**SUBMISSION ON NOTICE OF REQUIREMENT: ALTERATION TO NZTA-1
STATE HIGHWAY 1, D240003 ROLLESTON OVERPASS (NZ TRANSPORT
AGENCY WAKA KOTAHI)**

To: **Selwyn District Council**

Name of submitter: **McDonald's Restaurants (NZ) Limited**

Appendix A

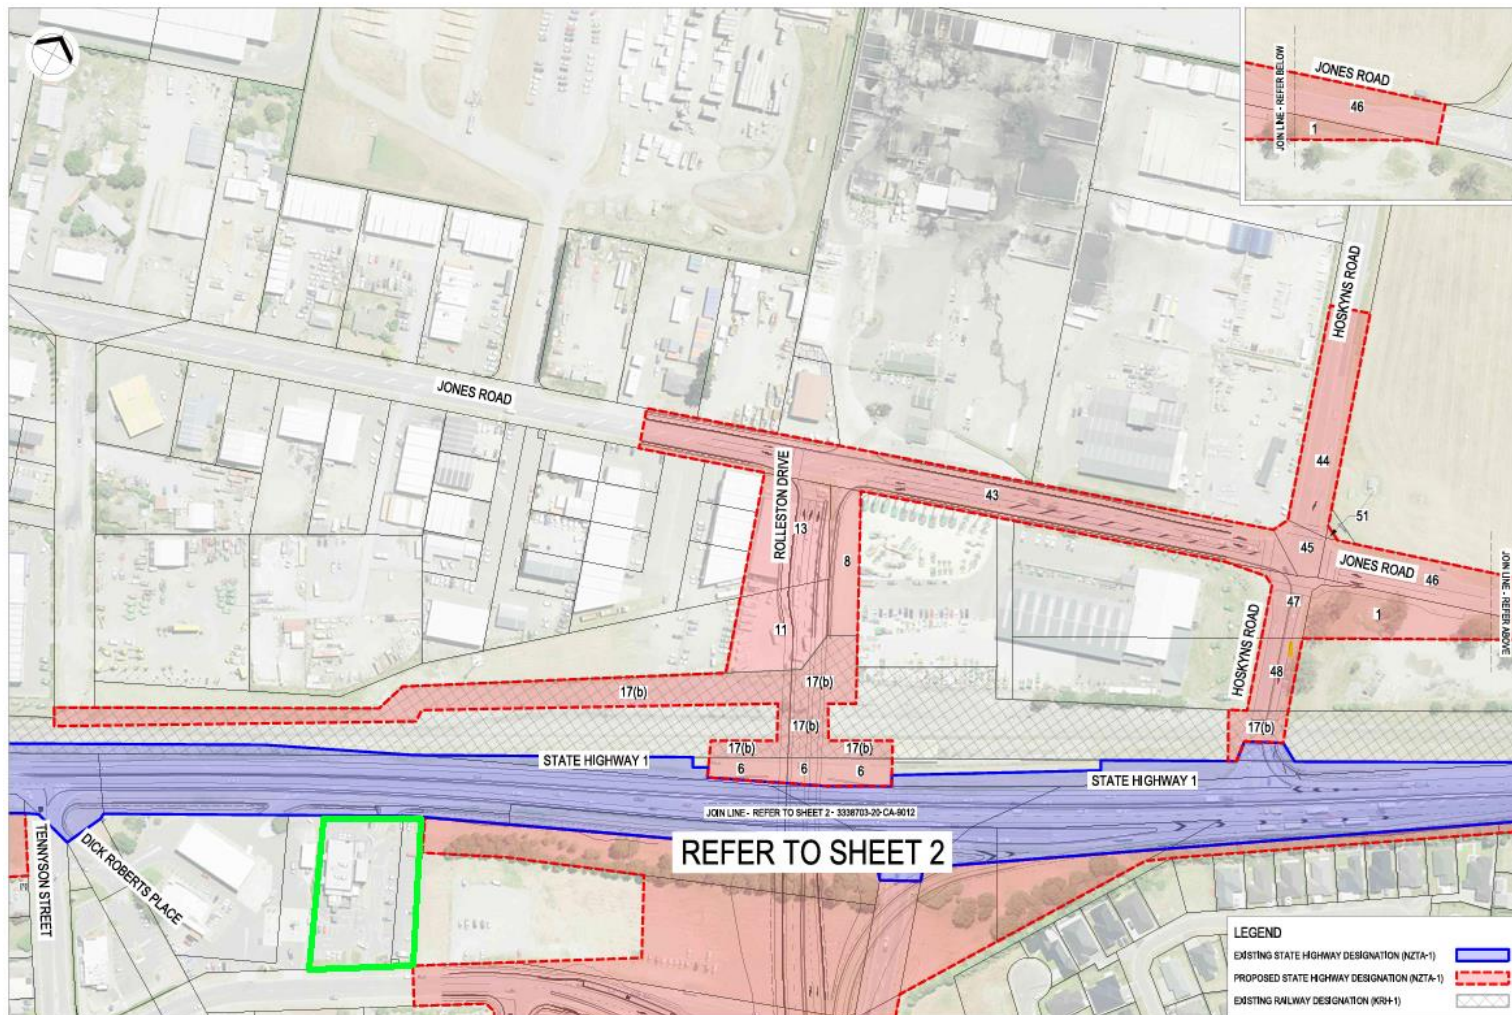
- 4 McDonald's owns a McDonald's restaurant (*the Restaurant*) at 15 Kidman Street, Rolleston (*the Site*), which is located adjacent to, and with access from, SH1 as identified in **Appendix A**. The Restaurant is operated by a local franchisee and has over 150 employees in total.
- 5 Currently the Restaurant can be accessed:
 - (a) Via left and right turns at the Kidman Street entry/exit.

Appendix B

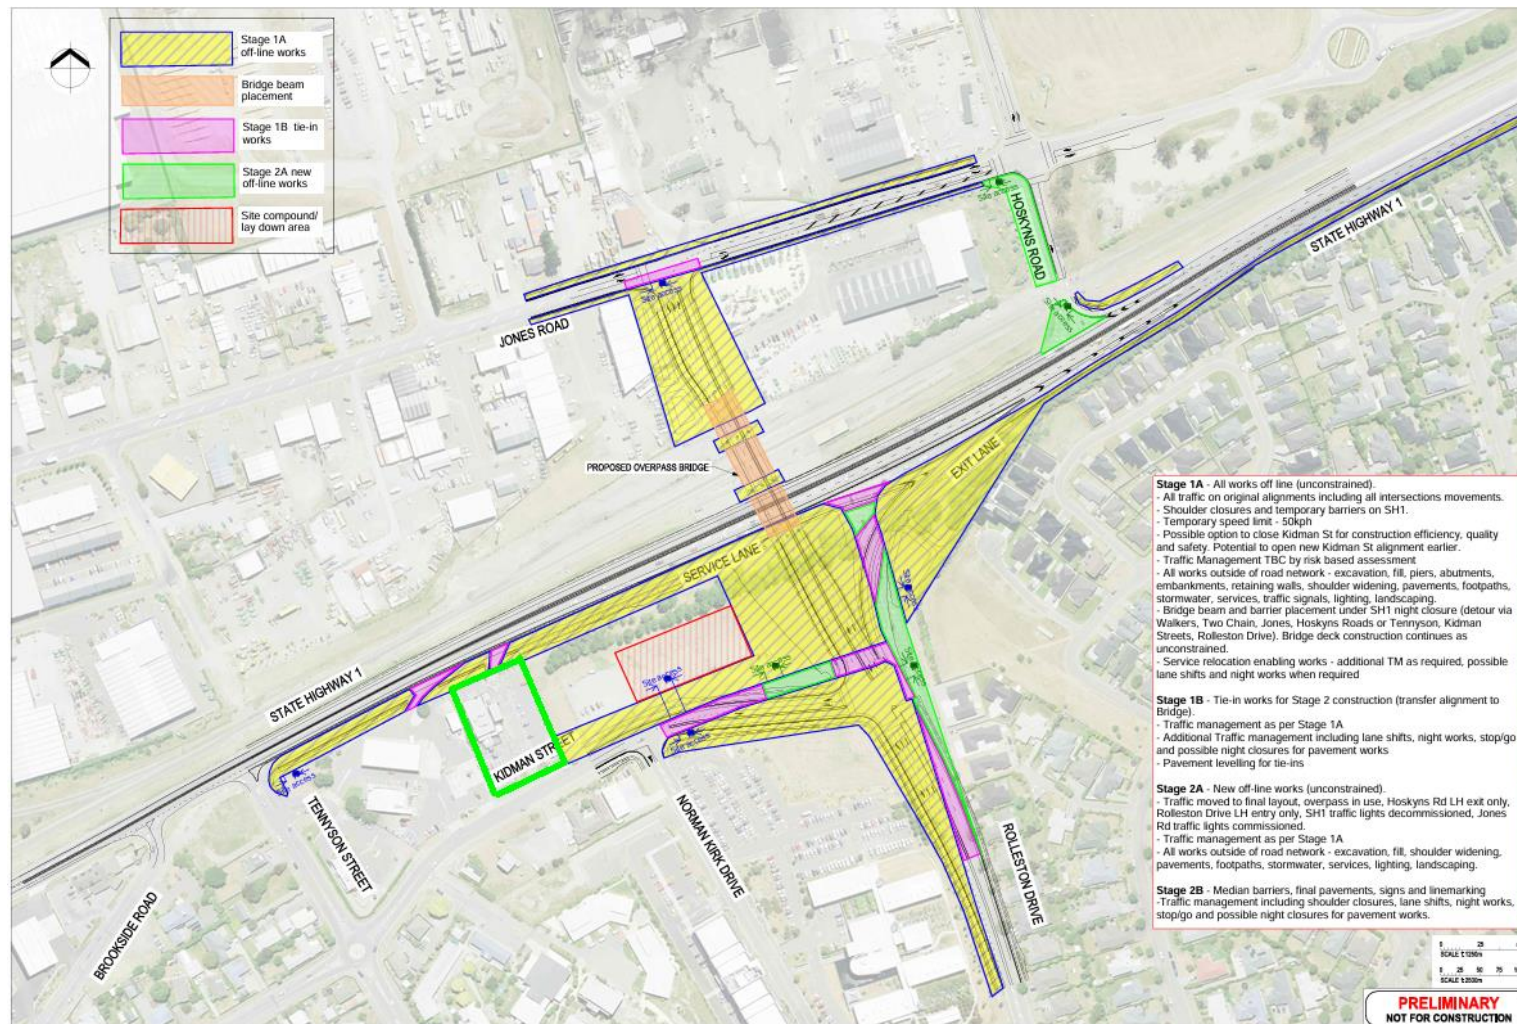
- (a) During construction, an area of land directly to the east of the Site is proposed to be used as a site compound/lay down area, as shown on

the image in **Appendix B**.² Use of this area has the potential to generate adverse amenity effects, including effects related to odour, dust and visual amenity. These effects may interfere with the dining experience of patrons and deter patrons from visiting the Restaurant.

- (b) Construction traffic accessing the site compound/lay down area may also interfere and conflict with vehicle movements travelling in and out of the Kidman Street vehicle access to the Restaurant.

- (iii) management or relocation of the proposed site compound/lay down area to minimise potential adverse amenity effects;
 - (iv) management of any disruption to the provision of utilities during relocation, including a requirement that disruptions be avoided to the extent practicable and, where unavoidable, sufficient advance notice be provided to McDonald's.

Appendix C

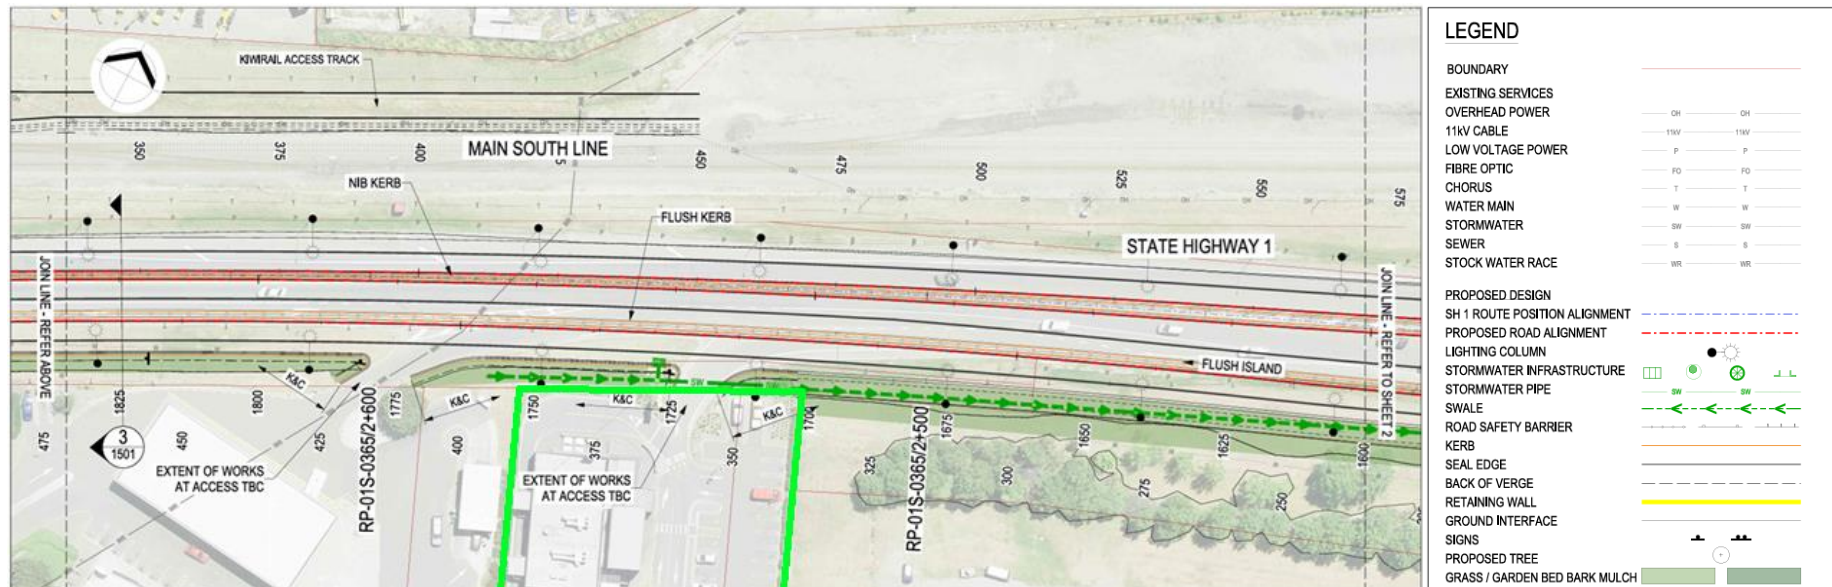
- (i) For westbound traffic, the simple left-turn entry off SH1 is proposed to be replaced with an auxiliary lane to access the McDonald's, BP and Tennyson Street with left turns separated by the main alignment of SH1 by a "flush island", as shown in the application diagram reproduced at **Appendix C**. To access the Restaurant via the auxiliary lane, motorists would need to decide to exit SH1 much earlier (about 500m further east) than is currently required. Accordingly, customers may miss the entrance to McDonald's, significantly reducing accessibility of the Site from SH1.

- (h) McDonald's also notes that the AEE indicates a swale will be constructed over the access to McDonald's off SH1 and that the extent of works at access is "TBC", refer **Appendix C**. Given the extent of changes already proposed to the accessibility of the Site, McDonald's is concerned to ensure that the access off SH1 is not further compromised.

- (b) That the proposed auxiliary lane access to McDonald's, BP and Tennyson Street be re-designed to provide greater accessibility to the Site from SH1 and that NZTA be required to consult with McDonald's in relation to the detailed design and associated signage.

- (c) That NZTA be required to provide further details on the extent of works proposed at the access to McDonald's off SH1.
- (d) That NZTA be required to consult with McDonald's on the detailed design of the right-turn closures and the upgraded intersection at SH1 and Dunns Crossing Road/Walker Road and associated signage.
- (e) Such alternative or consequential relief to give effect to the concerns raised in this submission.

Appendix D

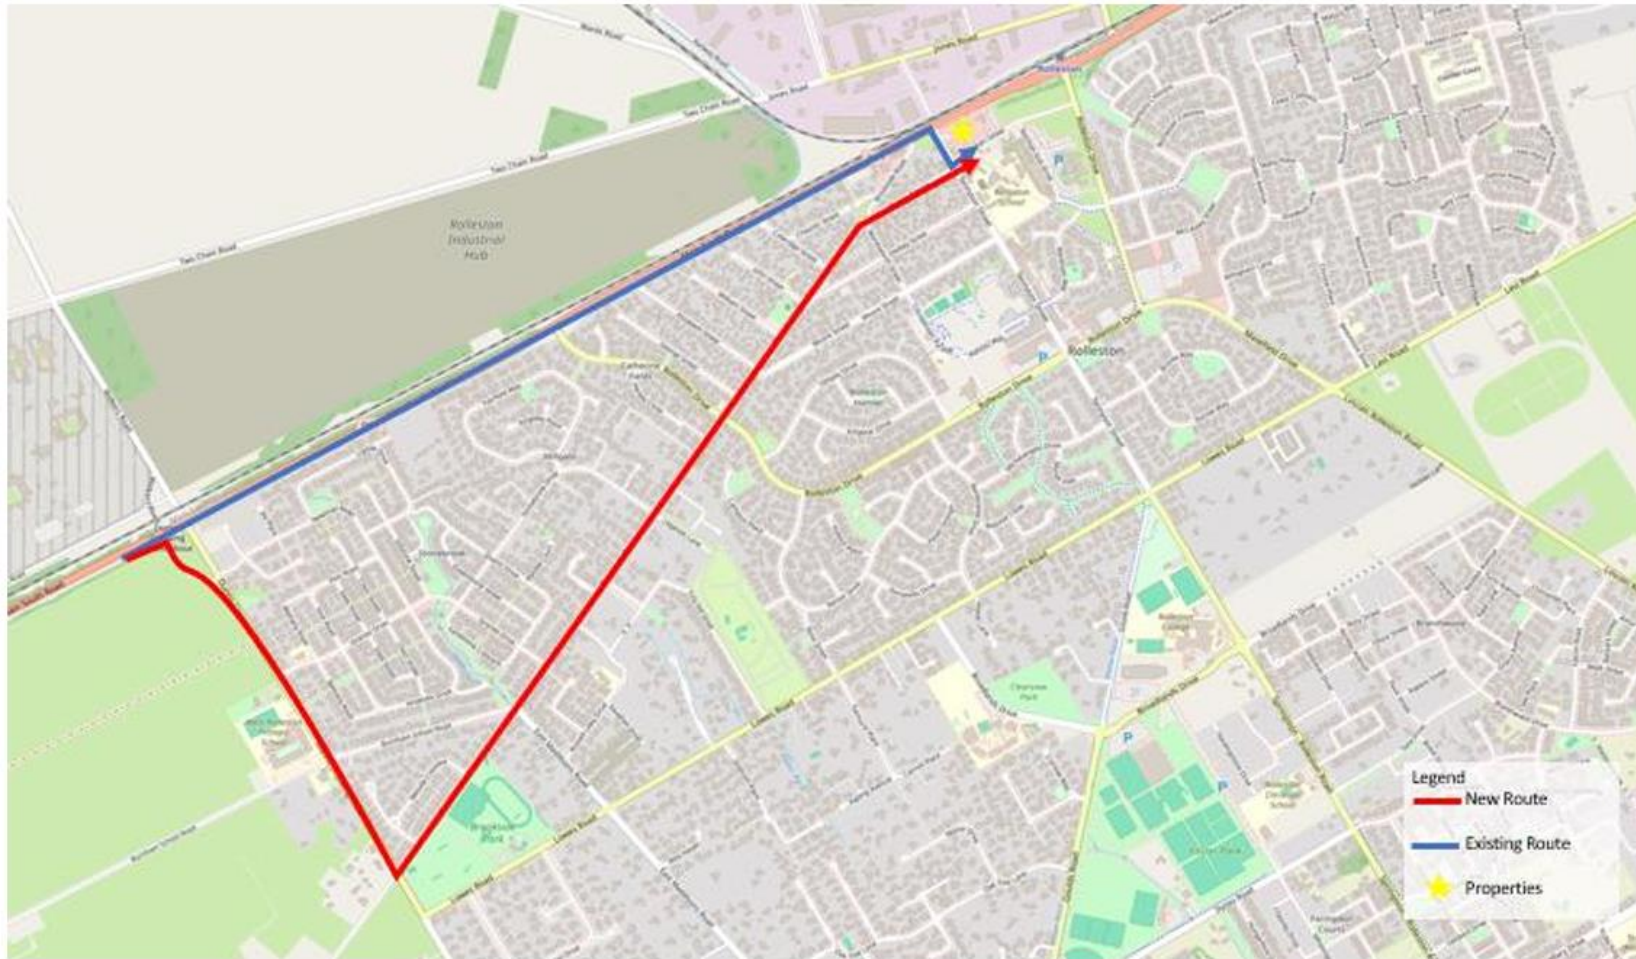
- (ii) For eastbound traffic along SH1 that currently accesses the Site primarily via right turn into Tennyson Street, the Project proposes that customers instead make a right turn at the Dunns Crossing Road/Brookside Road intersection, as illustrated in **Appendix D**. This intersection is proposed to be upgraded as part of Package 1 of the Project.⁶

- (iv) With the changes proposed by the Project, eastbound vehicles are expected to turn down Dunns Crossing Road to access the Restaurant, adding a detour of 1,300m and approximately three minutes of additional travel time.⁷ From this location, eastbound patrons would have no ability to see the Restaurant or identify the accessible route. The AEE describes the detour as "less than minor";⁸ however, the detour proposed by the Project would clearly significantly affect the ability for customers to easily identify and access the Restaurant.
